**ADDENDUM No. 002**

Date December 3, 2014

Project Name **Ullrich Water Treatment Plant Structural Repairs**

C.I.P. No. 5335.012

ARCADIS U.S., INC.  
DATE SEPTEMBER, 2014  
SHEET 2 OF 31  
CAD REF. NO. S00-01

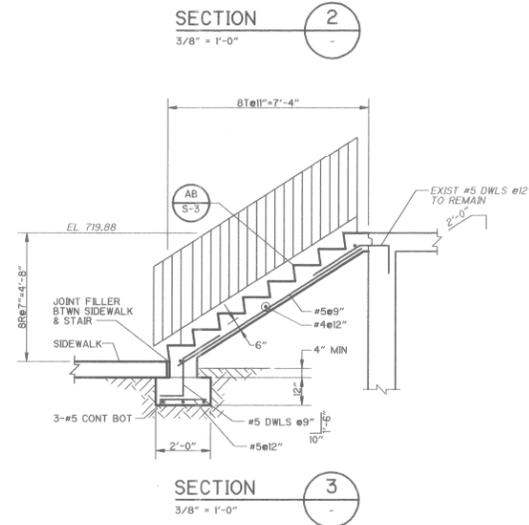
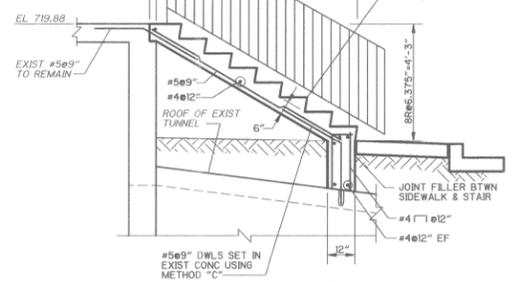
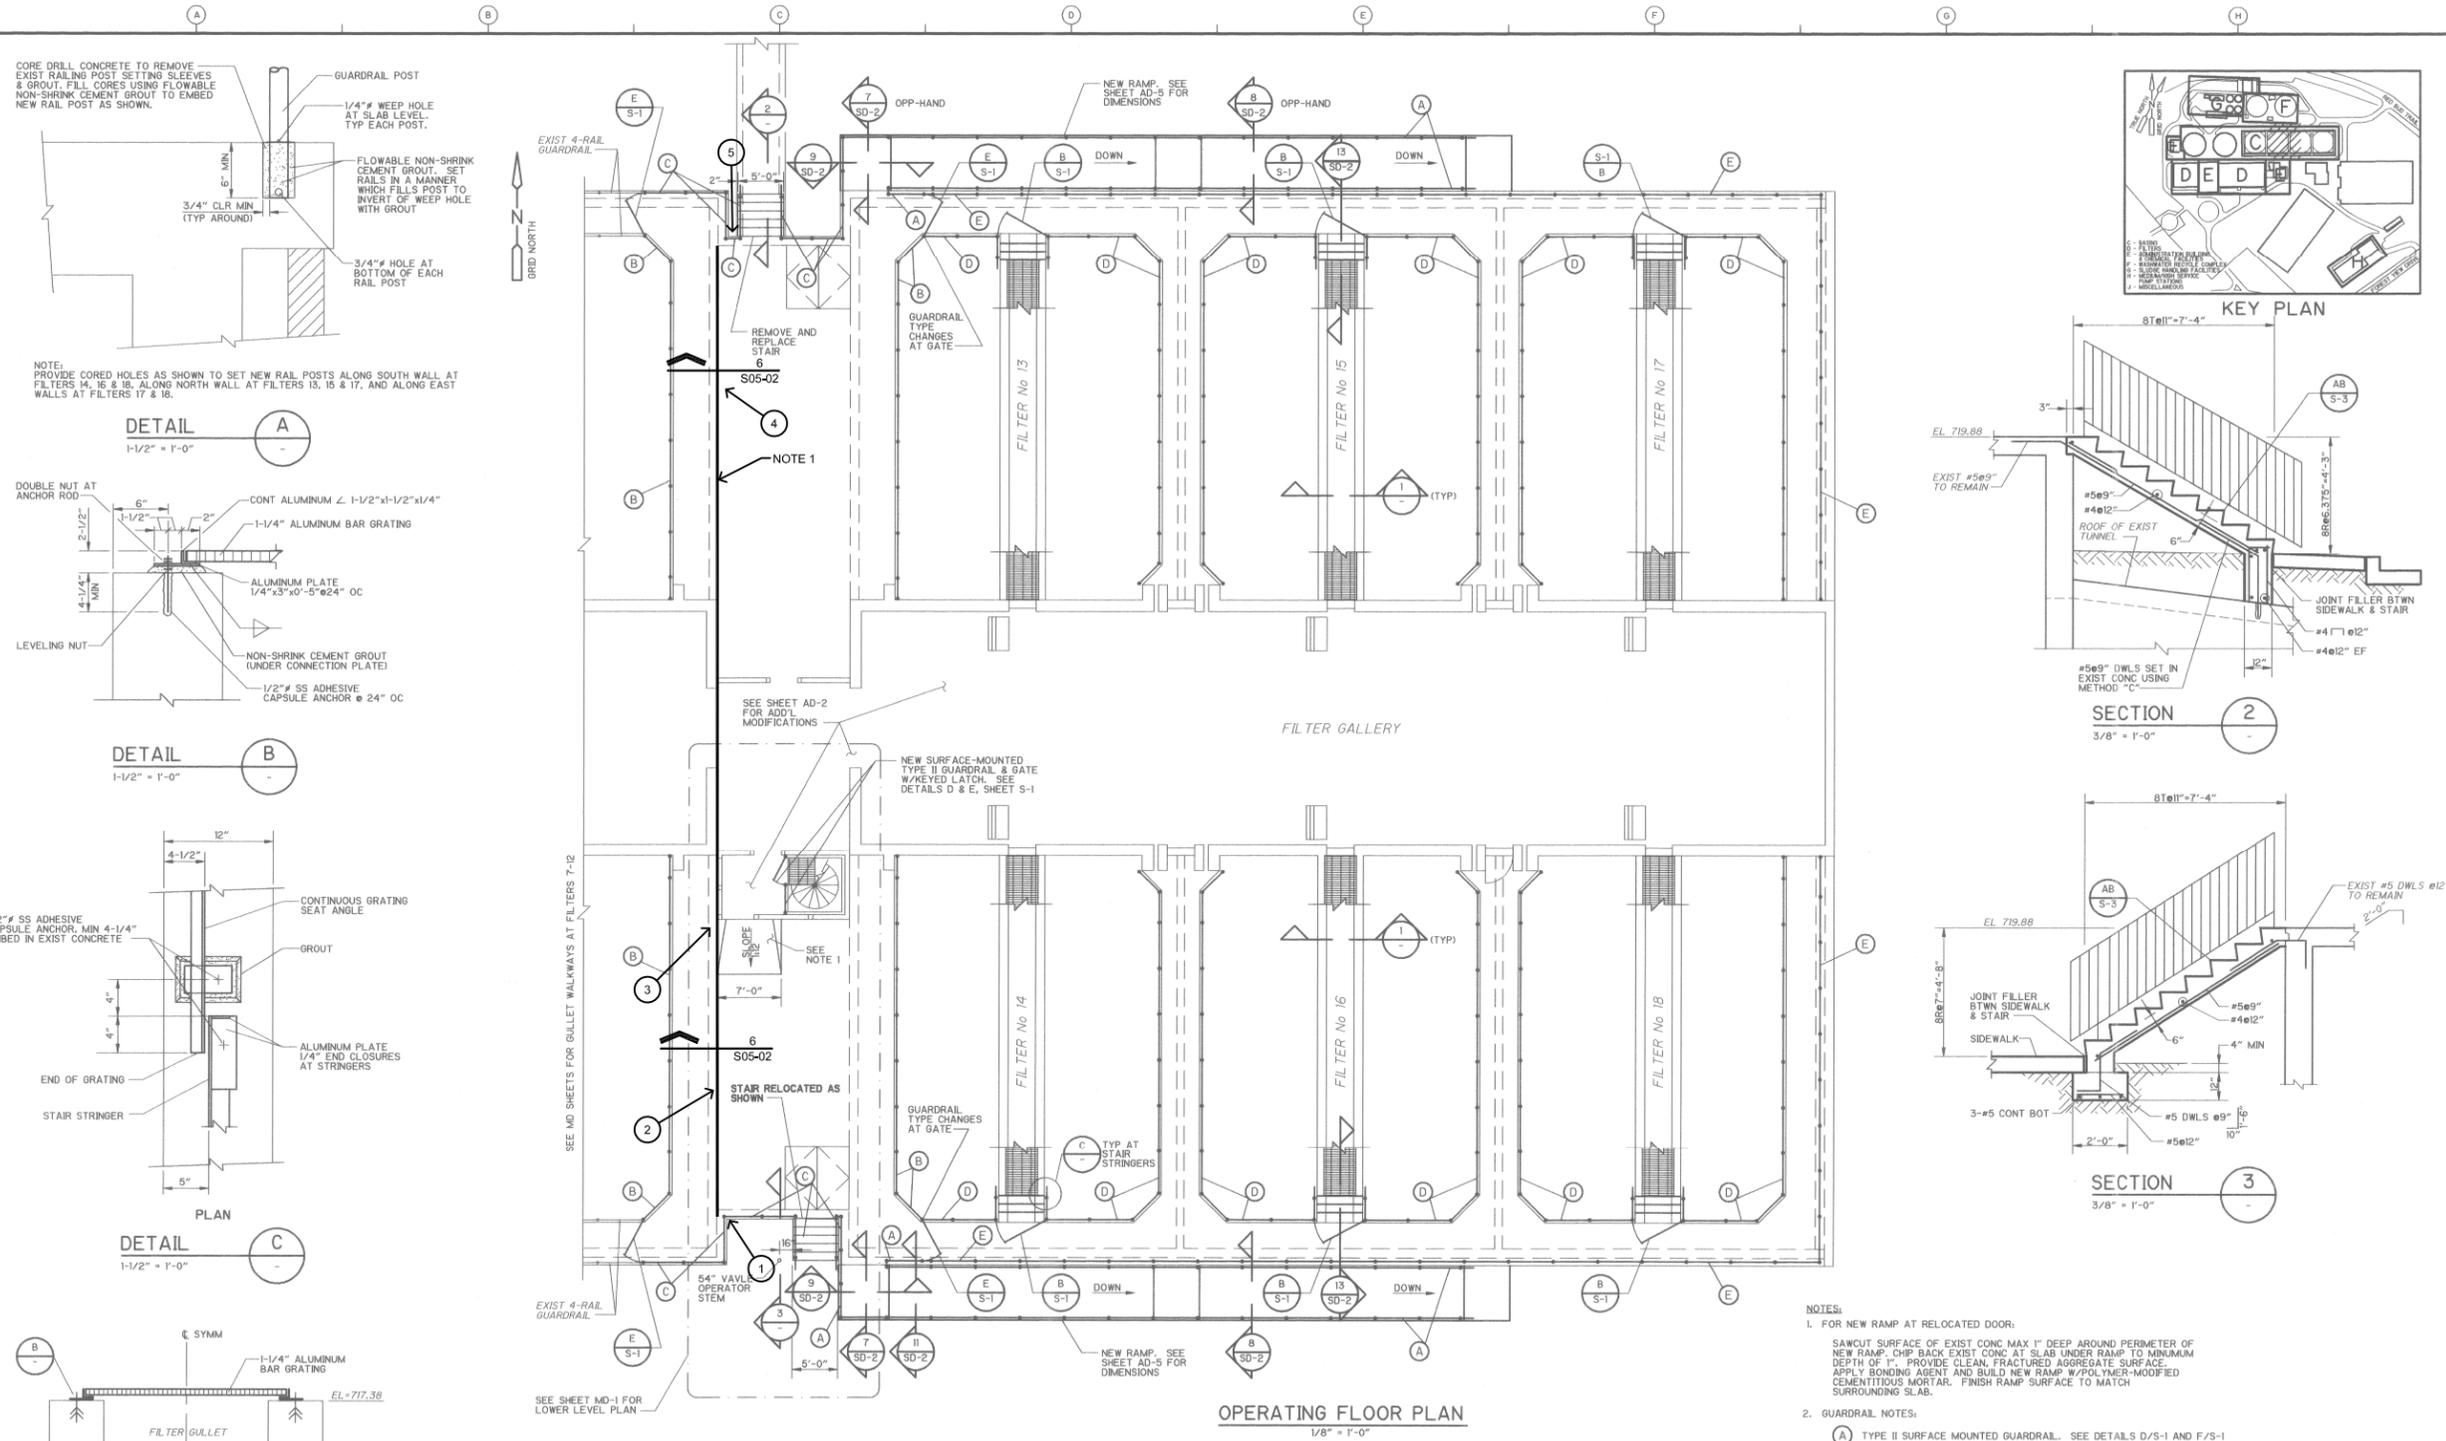
REVISIONS			
NO.	BY	DATE	REMARKS
1	KH	12/03/14	ADDENDUM 1 - ADJUSTED LINE ITEMS OF WORK

B - REMOVE AND REPLACE GRATING			
10	LIME HANDLING BUILDING	FLOOR DETERIORATION AND POOR DRAINAGE TO FLOOR DRAINS	A - INSTALL A FLOOR TOPPING SIMILAR TO WHAT WAS USED AT THE METERING LEVEL TO IMPROVE DRAINAGE TO FLOOR DRAINS	S10-1, S10-2	SF	4600
			B - CONCRETE COATING SYSTEM		SF	4600
11	CENTRIFUGE BUILDING	LEAKING EJ	A - INSTALL A NEW EJ WITH FILLER	S11-1, S11-2	LF	90

⑦ DETAIL  
NO SCALE

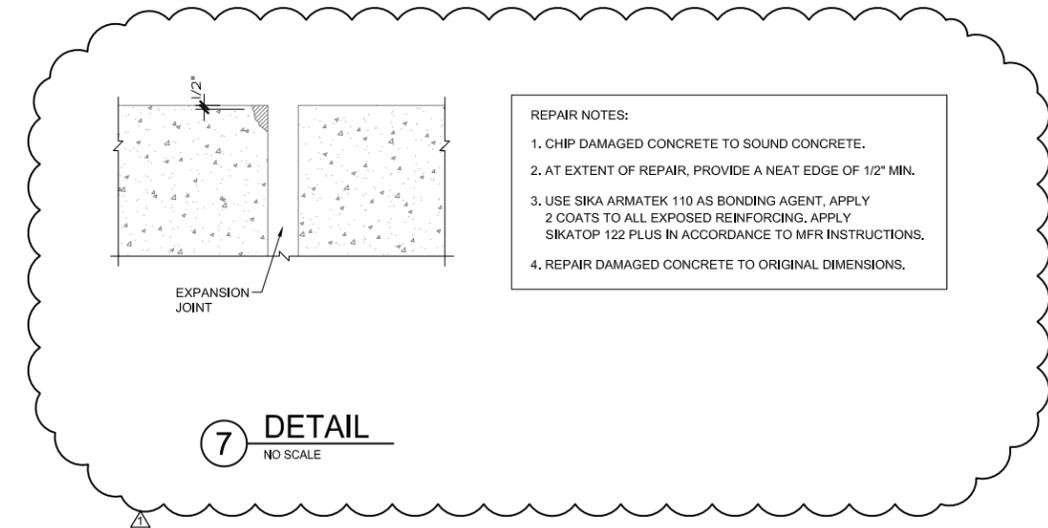
NO.		BY	DATE	REVISIONS	REMARKS
△		KH	12/03/14	ADDENDUM 2 - CONCRETE REPAIR DETAIL

- REPAIR NOTES:
1. CHIP DAMAGED CONCRETE TO SOUND CONCRETE.
  2. AT EXTENT OF REPAIR, PROVIDE A NEAT EDGE OF 1/2" MIN.
  3. USE SIKA ARMATEK 110 AS BONDING AGENT, APPLY 2 COATS TO ALL EXPOSED REINFORCING, APPLY SIKATOP 122 PLUS IN ACCORDANCE TO MFR INSTRUCTIONS.
  4. REPAIR DAMAGED CONCRETE TO ORIGINAL DIMENSIONS.

ARCADIS U.S., INC.  
DATE SEPTEMBER, 2014  
SHEET 24 OF 31  
CAD REF. NO. S08-02

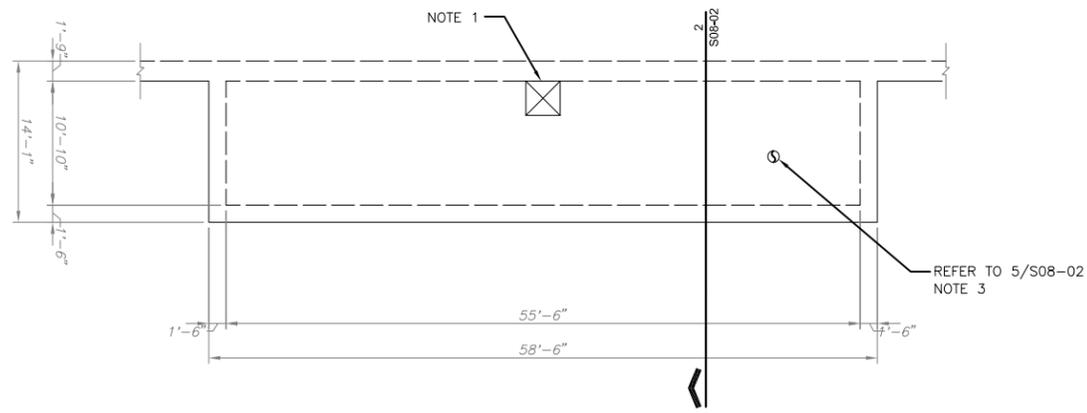
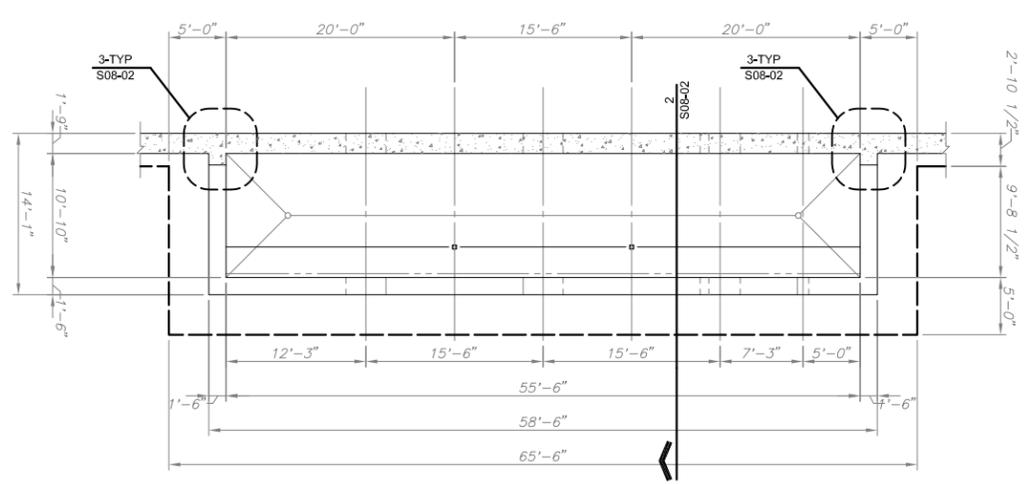
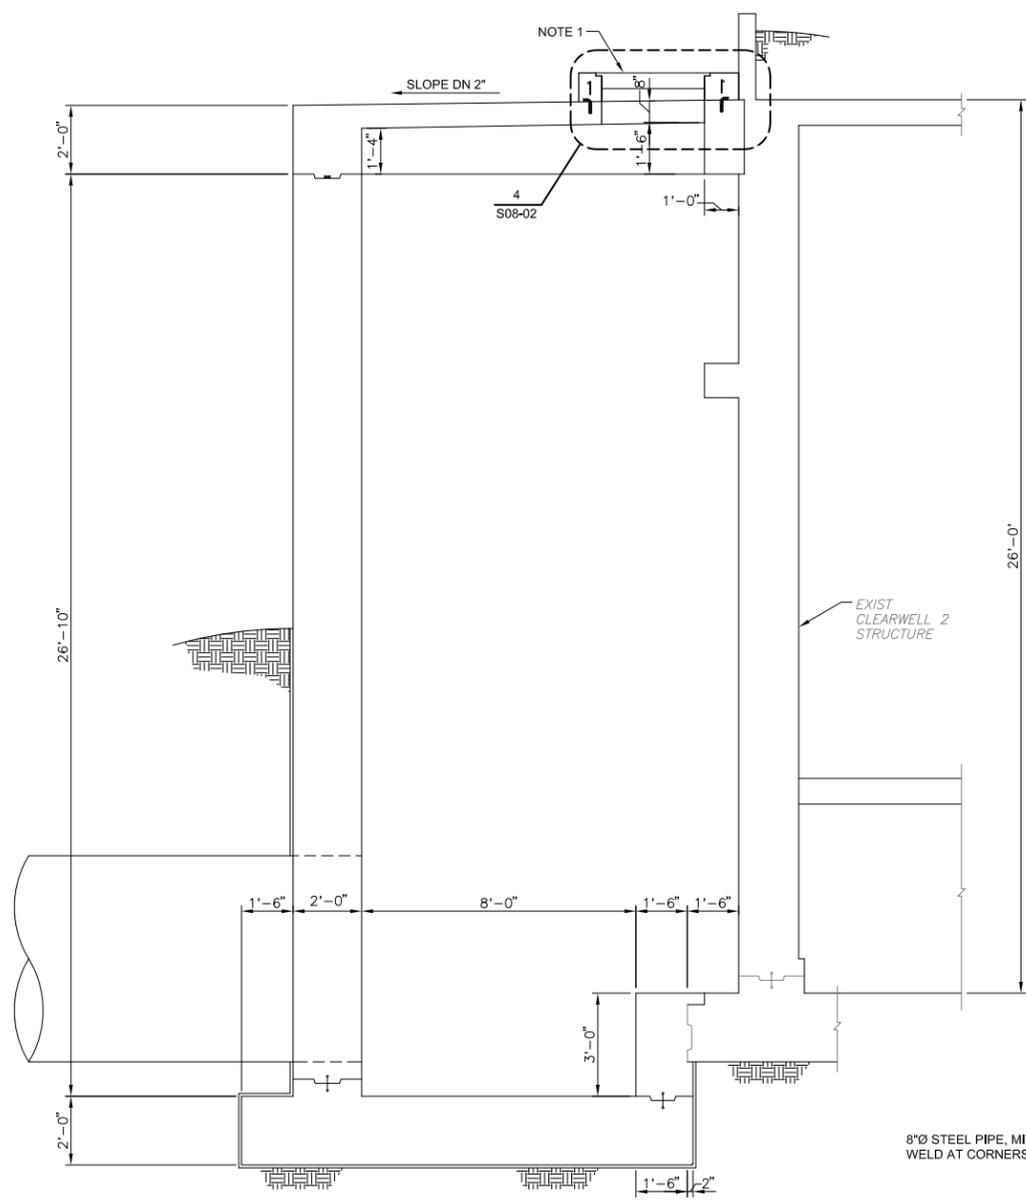
REVISIONS				
NO.	BY	DATE	REVISIONS	REMARKS
1	KH	12/03/14	ADDENDUM NO. 2 - CLARIFIED NOTE

- 36"x36" BILCO SST HATCH. COORDINATE WITH OWNER FOR HATCH LOCATION.
- SAW-CUT INTO EXISTING CONSTR JOINT. PARALLEL TO ORIGINAL CLEARWELL WALL. INSTALL GREENSTREAK HYDROTITE JOINT REPAIR STYLE #RSS-0806 C.
- NEW 8"Ø PIPE VENT W/ 16 MESH 304 SS, 0.018 SCREEN. COORDINATE WITH OWNER FOR VENT LOCATION AND COLOR.
- ACCESS TO CLEARWELL NO. 2 REQUIRES CONFINED SPACE ENTRY. SEE SPECIFICATIONS FOR REQUIREMENTS.

5. THE CONTRACTOR SHALL PROVIDE THE CITY A MINIMUM OF FOUR WEEKS' NOTICE TO DEWATER CLEARWELL NO. 2 TO CONDUCT THE WORK. THE CITY WILL BE RESPONSIBLE FOR DE-WATERING AND RE-ESTABLISHING FLOWS TO CLEARWELL NO. 2. THE CONTRACTOR SHALL TAKE SPECIAL CARE TO ISOLATE THE WORK AREA (APPROXIMATELY 10'-10" x 55'-6" x 28'-10" HIGH AREA) FROM THE REST OF CLEARWELL NO. 2 PRIOR TO THE WORK BY PROVIDING ACCEPTABLE BULKHEAD FOR THREE 7'-6" WIDE x 3'-6" HIGH OPENINGS APPROXIMATELY THREE FEET OFF OF THE FLOOR OF THE WORK AREA, ON THE CLEARWELL SIDE AND FOR THREE 72" PIPELINES ONE FOOT OFF THE FLOOR ON THE EXTERIOR WALL. CONTRACTOR SHALL ALSO BE RESPONSIBLE FOR DEWATERING AND CLEANING TO A DEPTH OF APPROXIMATELY THREE FEET BELOW THE OPENING FROM WORK AREA. CONTRACTOR SHALL BE RESPONSIBLE FOR DISINFECTING THE WORK AREA PRIOR TO THE CITY RE-ESTABLISHING FLOWS TO CLEARWELL NO. 2. THE CONTRACTOR WILL ALSO BE RESPONSIBLE FOR DISINFECTING ALL OF CLEARWELL NO. 2 IF DEBRIS ENTERS CLEARWELL NO. 2 BEYOND THE WORK AREA. THE MAXIMUM TIME THAT CLEARWELL NO. 2 WILL BE DOWN IS TWO (2) WEEKS.

ARCADIS U.S., INC.  
 DATE SEPTEMBER, 2014  
 SHEET 31 OF 31  
 CAD REF. NO. S11-02

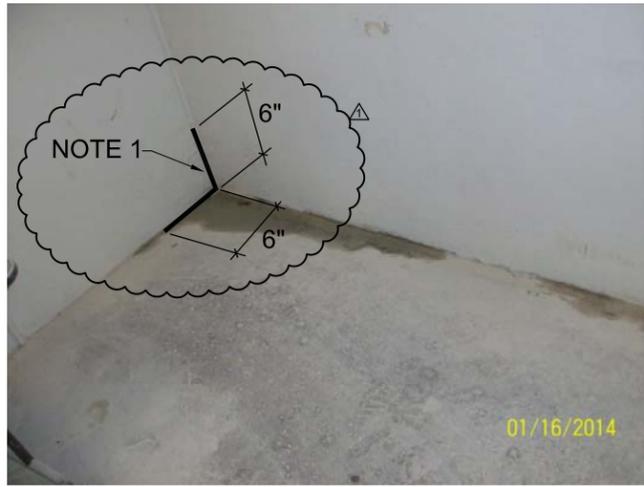
REVISIONS			
NO.	BY	DATE	REMARKS
1	KH	12/03/14	ADDENDUM 2 - EXTENDED JOINT SEALANT UP THE WALL

SHEET NOTES:  
 1. EXTEND NEW JOINT SEALANT UP THE WALL A MIN. OF 6"  
 2. INSTALL THE SEALANT CONT. UP AND ACROSS THE CONCRETE PAD AT THE FACE OF CMU WALL.
